SERVICE BULLETIN

APPLICABILITY: 2019-23MY Forester

NUMBER: 07-218-23R

SUBJECT: Genuine Alternative Battery Replacement

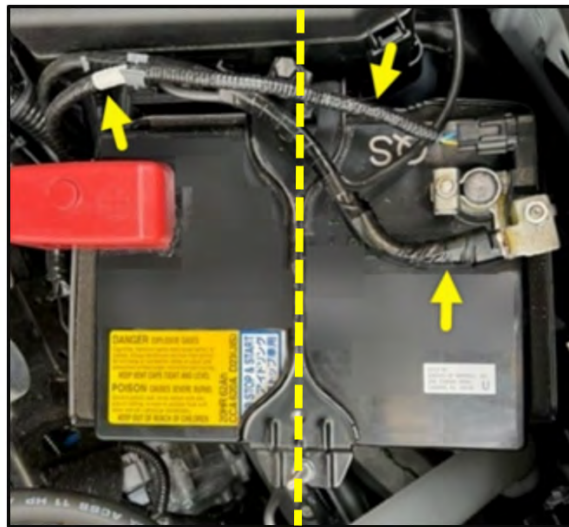
STEP 4: Install the NEW battery cover (p.n. 82123AN000) to the alternative replacement battery. Confirm the bottom of the cover is aligned flush with the bottom of the battery.
